**Combined Residents of Whitehorse  
Action Group (CROWAG) Incorporated.**

**Submission to the Suburban Rail Loop East Precincts Standing  
Advisory Committee - Box Hill.**

**21st October 2025**

Figure 1. Map depicting the proposed active transport network Draft Structure Plan Page 73.

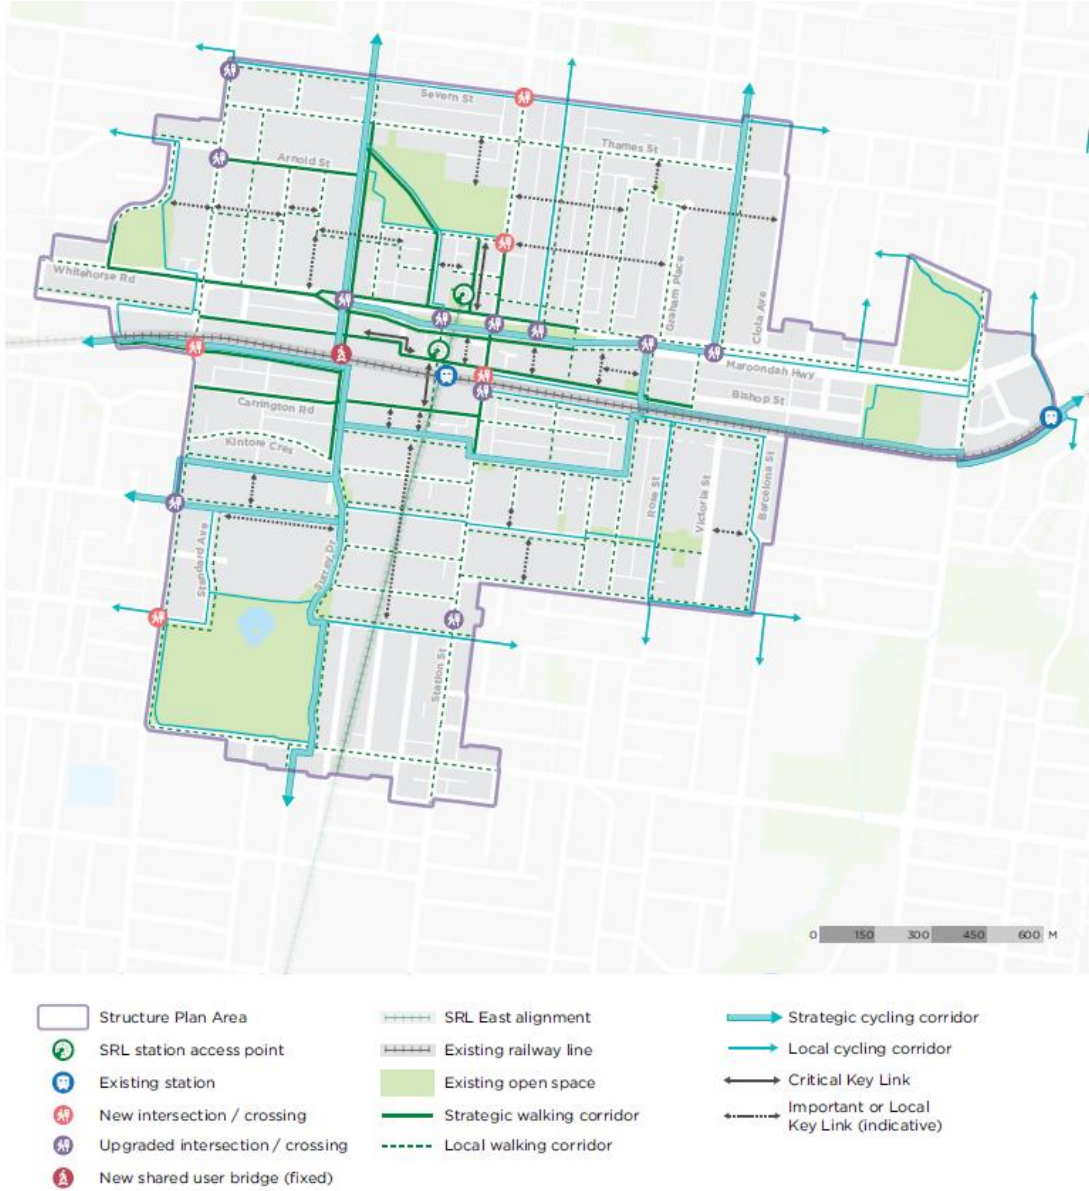
It is pleasing to note the need for the Thurston connection is acknowledged again, as it was in the 2007 Box Hill Structure Plan, however now placed into the long-term action list, the level of service for cyclists, pedestrians and commuters will continue to be very poor.

**Under specific issues related to Urban Design the panel questions if planning for active transport is appropriate. We would suggest it is not. It could well be 40-50 years before the 2007 Action - 'Grade separated access for pedestrians and bicycles across the railway to link Thurston Street to Nelson Road.' Is a reality. The number of resulting additional car journeys from that delay would be very significant.**

Figure 2. Overview of the Strategic Cycle Corridors through Box Hill.

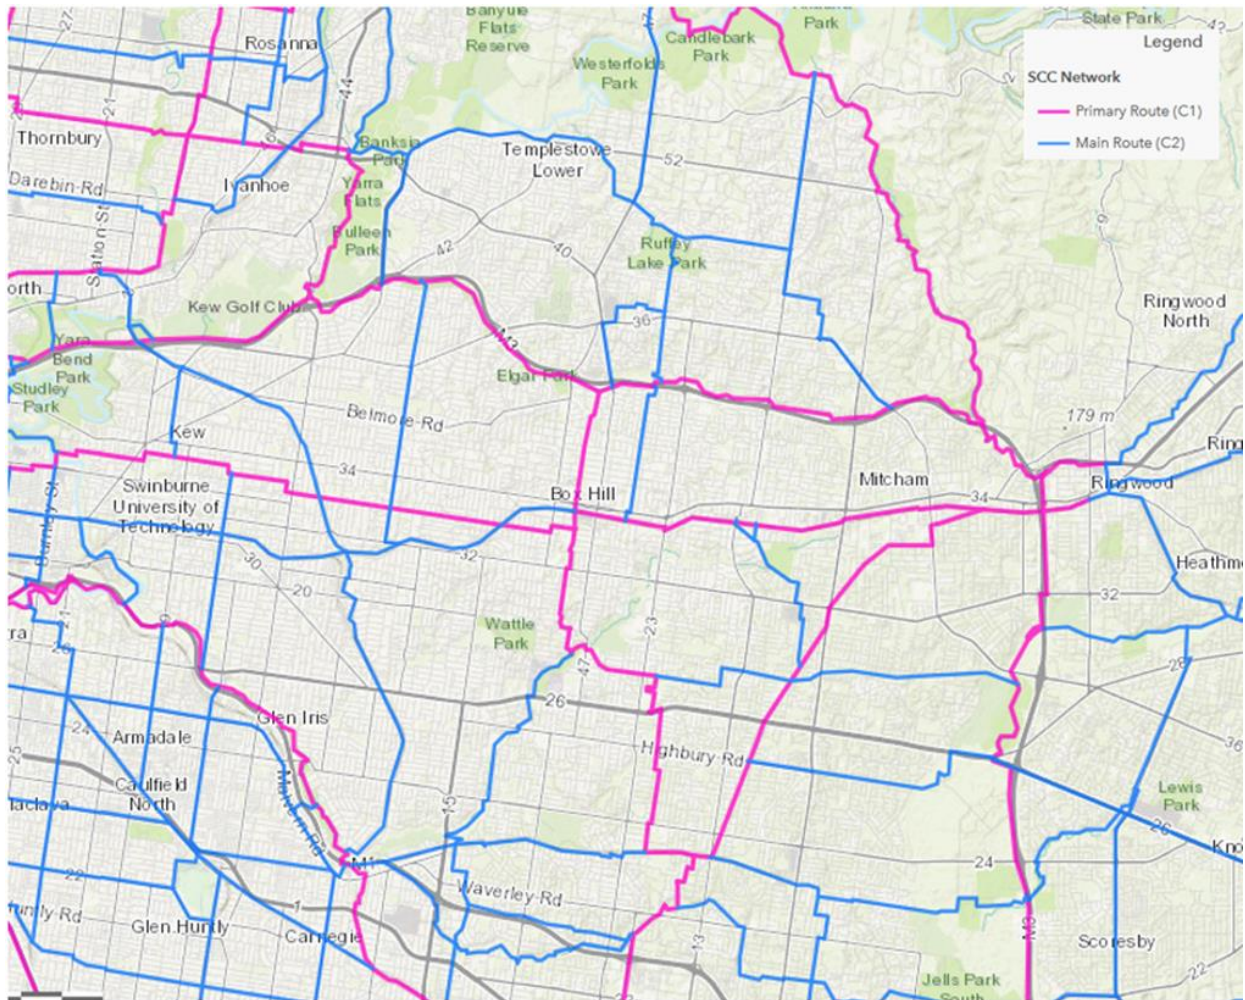
- **Will the primary routes of the principal bicycle network be kept open** - north/south and east/west, during the Vicinity development phase and the SRL development phase the current loading bay link will be unavailable. It could be 10-15 years, under the current structure plan before the Thurston Street overpass is constructed. What is the maximum acceptable interruption to a primary cycling route. Would we accept loss of an arterial road for a similar time?

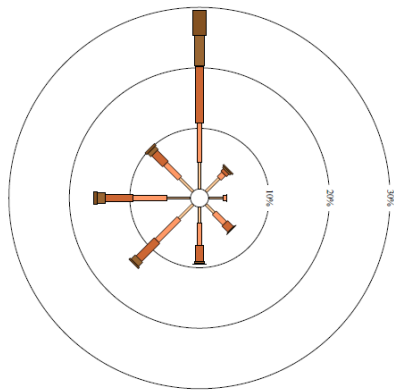
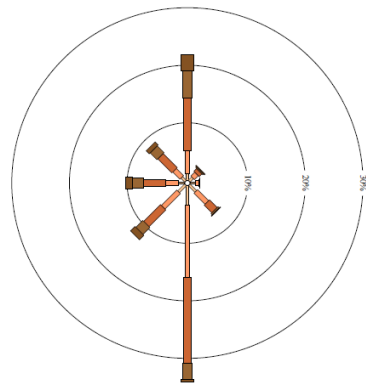
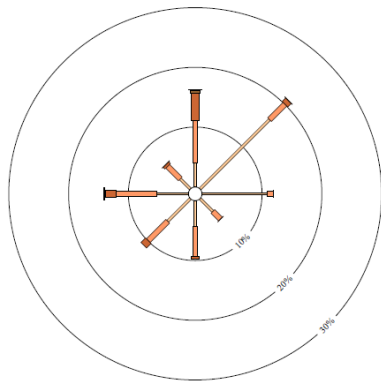
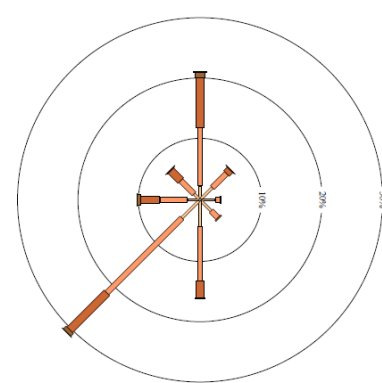
The wind analysis used in the Vicinity development application identified acceptable but not ideal impacts. The analysis was based on conditions expected in the Melbourne CBD and based on data collected from the Bureau of Meteorology (BoM) site at Essendon. The upstream terrain of the CBD is very different to that of Box Hill. The flat Basalt Plains and Port Phillip Bay surrounding the CBD are very different from the rolling

hills and the Dandenong Ranges that impact Box Hill. BoM wind data expressed in wind roses for Essendon and Viewbank (the closest BoM wind data site to Box Hill) show big differences in the prevailing wind direction and average wind speed.

The wind analysis doesn't appear to take account of the impact of funnelling between towers or the downstream impacts of wind turbulence on nearby residential areas from high rise towers.

8.0 Wind Impact Reports required of the schedules for the built form overlay should consider downstream turbulence impacts of development proposals as well as impacts on the private open space of residential balconies. They should use contemporary modelling techniques.
